# Access Compliance Report

## Public Rights-of-Way

Intersection ID: 32319	Main Street: ARDREY_KELL_RD	Cross Street: BRIDGEVIEW_LN	Location: NW
ADA ID: 827BDD3DDBF5	Ramp Type: Perp	Initial Pass/Fail: Fail	Overall Compliance: No
			Severity Score: 13.75

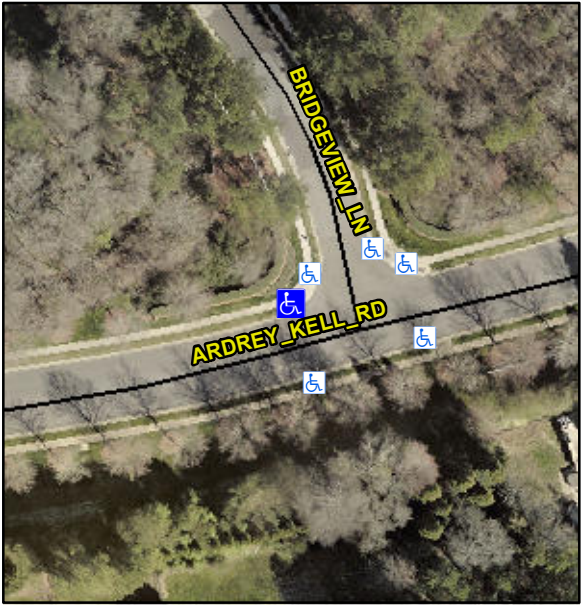
Codes/Mitigation Info/Possible Solution			Field Measurements/Component Compliance		
	Possible Solutions:		<b>Compliance</b>	<b>Description</b>	<b>Data</b>
	<b>Remove &amp; Replace Entire Ramp.</b>		<b>No</b>	Ramp Length (in)	50.5
			<b>Yes</b>	Ramp Width (in)	61.0
			<b>N/A</b>	Flare Type LT	N/A
			<b>N/A</b>	Flare Slope LT (%)	N/A
			<b>N/A</b>	Flare Traversable LT?	N/A
			<b>N/A</b>	Landing Length (in)	N/A
			<b>N/A</b>	Landing Width (in)	N/A
			<b>N/A</b>	Landing Slope (%)	N/A
			<b>N/A</b>	Landing X Slope (%)	N/A
<p>Surveyor Notes:</p> <p><b>N/A</b></p> <p>PROW/ADA:</p> <p><b>Not Found, R304.2.2, R304.5.3</b></p>			<b>N/A</b>	Flare Type RT	N/A
			<b>N/A</b>	Flare Slope RT (%)	N/A
			<b>N/A</b>	Flare Traversable RT?	N/A
			<b>N/A</b>	DWS Provided?	N/A
			<b>N/A</b>	DWS Contrast?	N/A
			<b>N/A</b>	DWS Length (in)	N/A
			<b>N/A</b>	DWS Full Width?	N/A
			<b>N/A</b>	DWS Offset (in)	N/A
			<b>N/A</b>	Shared Landing?	N/A

<b>N/A</b>	Gutter Ponding?	N/A
			<b>N/A</b>	Gutter Lip Ht (in)	N/A
			<b>No</b>	Painted X Walk1?	N/A
				X Walk 1 Direction	To S
			<b>N/A</b>	X Walk 1 Width (in)	N/A
			<b>4.2</b>	X Walk 1 Slope (%)	N/A
			<b>2.3</b>	X Walk 1 X Slope (%)	N/A
			<b>N/A</b>	Ramp inside XWalk1?	N/A
			<b>N/A</b>	Road Slope (%)	N/A
			<b>N/A</b>	Road X Slope (%)	N/A
			<b>N/A</b>	Any Obstructions?	N/A
				Obstruction Type	
			<b>N/A</b>		
			<b>N/A</b>		
			<b>N/A</b>		
			<b>N/A</b>		
			<b>N/A</b>		
			<b>N/A</b>		
			<b>N/A</b>		
			<b>N/A</b>		
			<b>N/A</b>		
Total Cost:		\$ 1850.00			
			<b>N/A</b>		
			<b>Yes</b>	Surface Condition? (G/P)	Good
